SUBJECT: ISSUANCE OF AMENDMENTS - McGUIRE NUCLEAR STATION, UNITS 1 AND 2
(TAC NOS. M89744 AND M89745)

Amendment No. 159
License No. NPF-9

Amendment No. 141
License No. NPF-17

SAFETY EVALUATION BY THE OFFICE OF NUCLEAR REACTOR REGULATION
RELATED TO AMENDMENT NO. 159 TO FACILITY OPERATING LICENSE NPF-9
AND AMENDMENT NO. 141 TO FACILITY OPERATING LICENSE NPF-17
DUKE POWER COMPANY
MCGUIRE NUCLEAR STATION, UNITS 1 AND 2
DOCKET NOS. 50-369 AND 50-370

Table 3.9-1

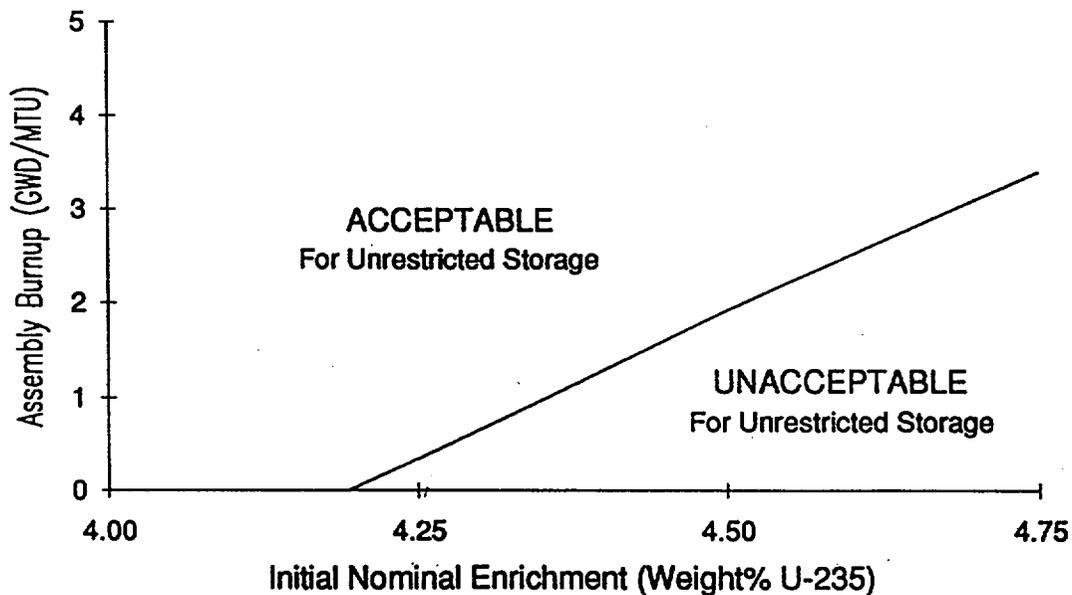
New or irradiated assemblies with initial enrichments up to 4.75 w/o U-235 which do not meet the requirements for unrestricted storage in Region 1, but which require temporary placement in Region 1 for operational requirements, must be placed in a restricted loading pattern. Reactivity analyses for these assemblies, arranged in a three-out-of-four storage configuration, were performed using the previously discussed methods. Acceptable fuel assemblies which qualify for storage in the fourth storage location of each three-out-of-four pattern are shown in Table 3.9-2 and are referred to as filler assemblies. These filler assemblies were also determined from minimum burnup versus initial enrichment calculations as described above.

<u>Initial Nominal Enrichment (Weight% U-235)</u>	<u>Assembly Burnup (GWD/MTU)</u>
4.19 (or less)	0
4.20	0.04
4.50	1.92
4.75	3.40

Fuel which differs from those designs used to determine the requirements of Table 3.9-1 may be qualified for Unrestricted Region 1 storage by means of an analysis using NRC approved methodology to assure that k_{eff} is less than or equal to 0.95.

Table 3.9-3

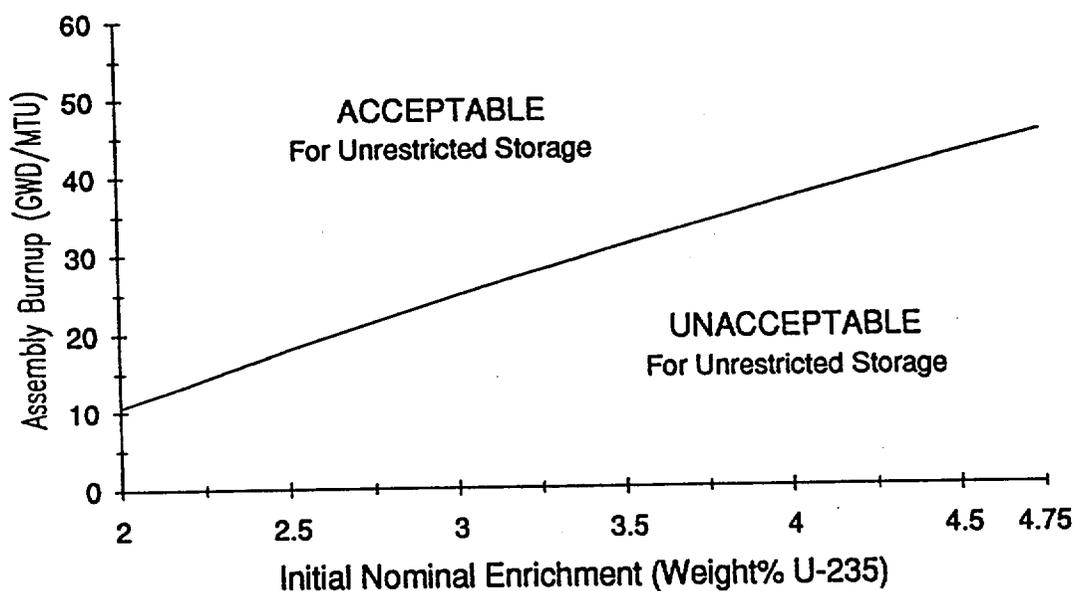
Region 2 of the McGuire spent fuel pools has similarly been analyzed for storage of fuel initially enriched to a maximum 4.75 w/o U-235. Table 3.9-3 shows the minimum burnup required for unrestricted storage in this region, ranging up to 45.10 GWD/MTU for an assembly initially enriched to 4.75 w/o. Table 3.9-4 shows the minimum burnup requirements for restricted storage, i.e., a two-out-of-four configuration, with the remaining two locations either vacant or containing filler assemblies. The minimum qualifying burnup versus initial enrichment for Region 2 filler assemblies are given in Table 3.9-5. Fuel assemblies which do not meet any of these burnup requirements may be placed in a checkerboard configuration in Region 2, but each adjacent cell must remain empty.

Initial Nominal Enrichment (Weight% U-235)	Assembly Burnup (GWD/MTU)
2.00 (or less)	10.54
2.50	17.96
3.00	24.64
3.50	30.86
4.00	36.75
4.50	42.38
4.75	45.10

Fuel which differs from those designs used to determine the requirements of Table 3.9-3 may be qualified for Unrestricted Region 2 storage by means of an analysis using NRC approved methodology to assure that k_{eff} is less than or equal to 0.95.

Figure 3.9-1

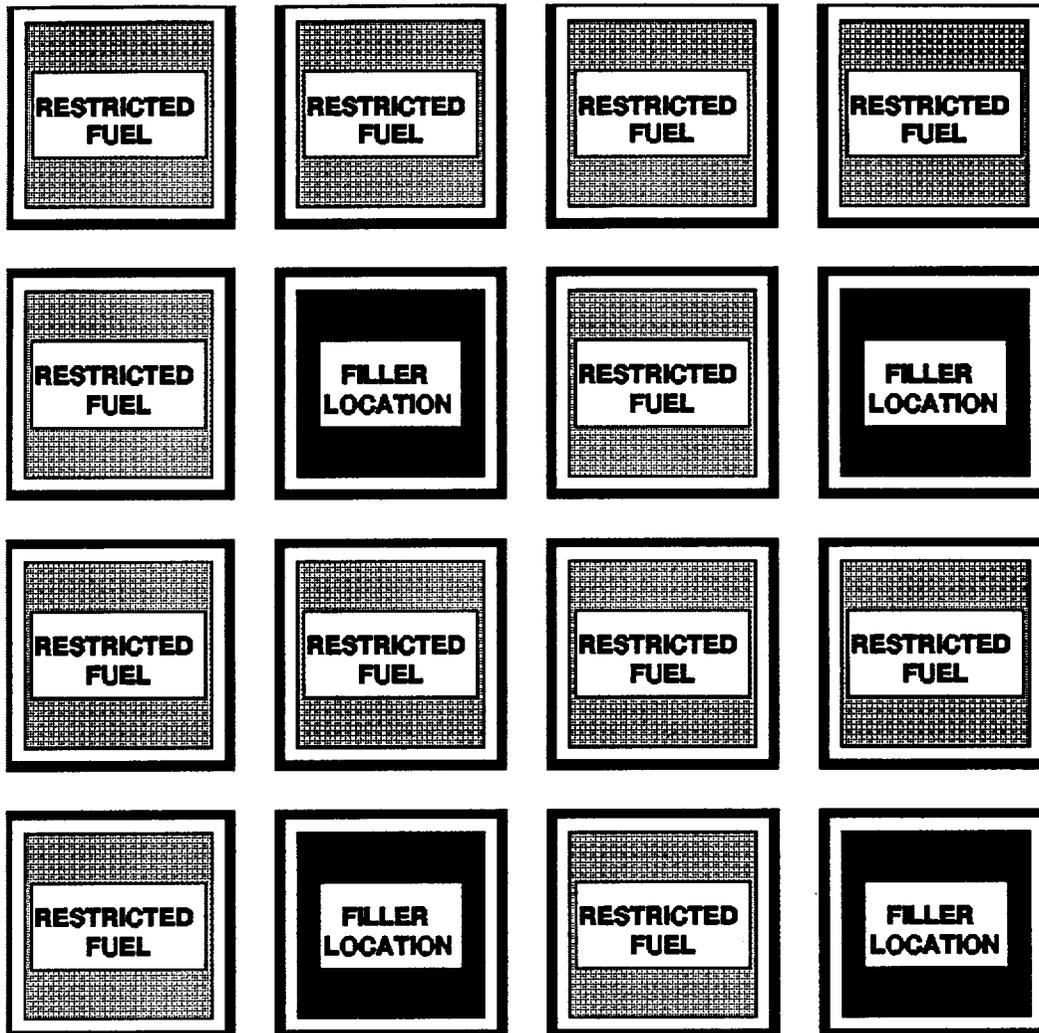
If both restricted and unrestricted storage is used in Region 1, an additional criteria has been imposed to ensure that the boundary row between these two configurations would not locally increase the reactivity above the required limit. Likewise if checkerboard storage is used in Region 2, an additional restriction has been imposed on the boundaries of the checkerboard storage region to ensure that the reactivity would not increase above the required limit. No other restrictions on region interfaces are necessary.

Restricted Fuel: Fuel which does not meet the minimum burnup requirements of Table 3.9-1. (Fuel which does meet the requirements of Table 3.9-1, or non-fuel components, or an empty location may be placed in restricted fuel locations as needed)

Filler Location: Either fuel which meets the minimum burnup requirements of Table 3.9-2, or an empty cell.

Boundary Condition: Any row bounded by a Region 1 Unrestricted Storage Area shall contain a combination of restricted fuel assemblies and filler locations arranged such that no restricted fuel assemblies are adjacent to each other.

Example: In the figure above, row 1 or column 1 can not be adjacent to a Region 1 Unrestricted Storage Area, but row 4 or column 4 can be.

Figure 3.9-2

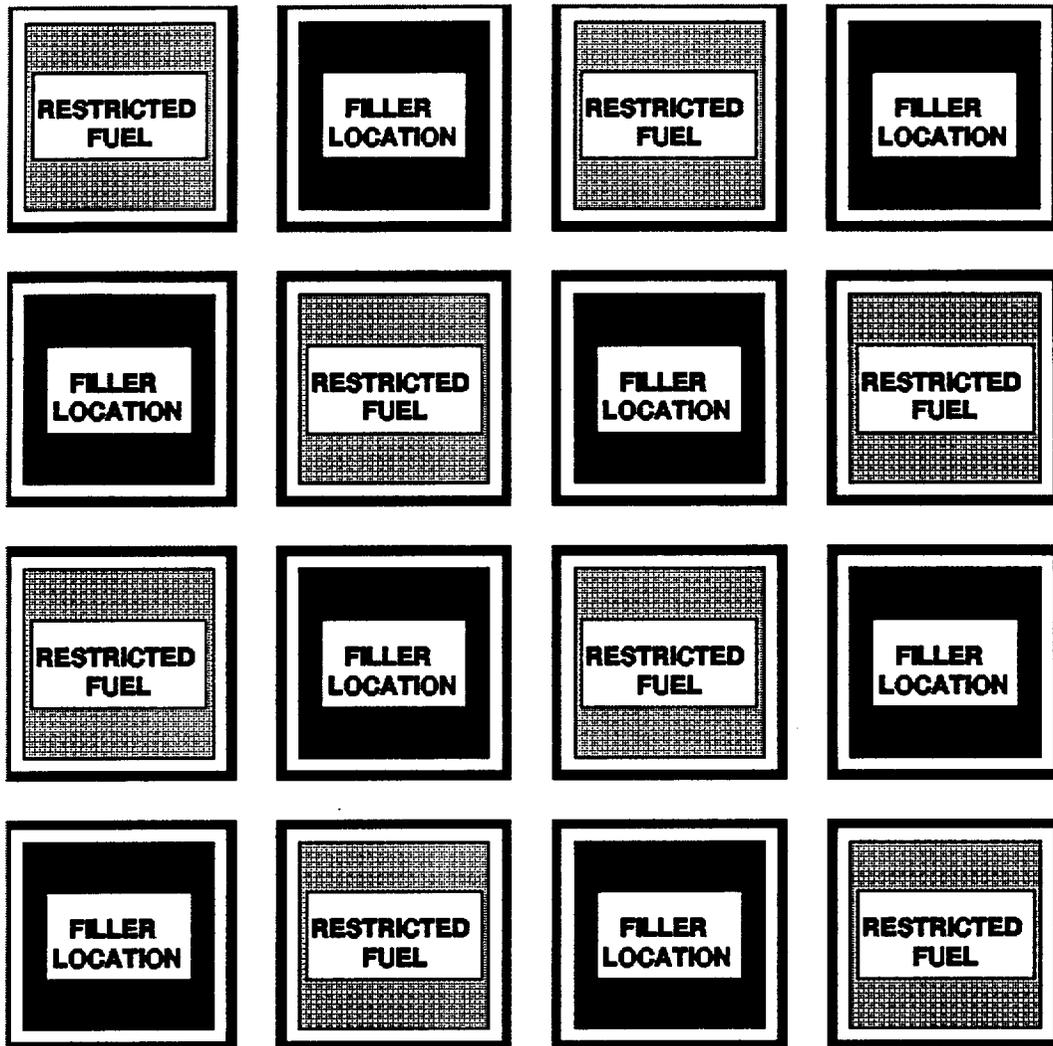
For storage in Region 2 requiring loading pattern restrictions, (per Specifications 3.9.13.b.2 or 3.9.13.b.3) fuel may be stored in either the "cell" or "non-cell" locations. "Cell" locations are the areas inside the fabricated storage cells and "non-cell" locations are the storage locations created by arranging the fabricated storage cells in a checkerboard configuration. Hence the "non-cell" locations are the areas defined by the outside walls of the 4 adjacent "cell" locations.

Restricted Fuel: Fuel which meets the minimum burnup requirements of Table 3.9-4, or non-fuel components, or an empty location.

Filler Location: Either fuel which meets the minimum burnup requirements of Table 3.9-5, or an empty cell.

Boundary Condition: No restrictions on boundary assemblies.
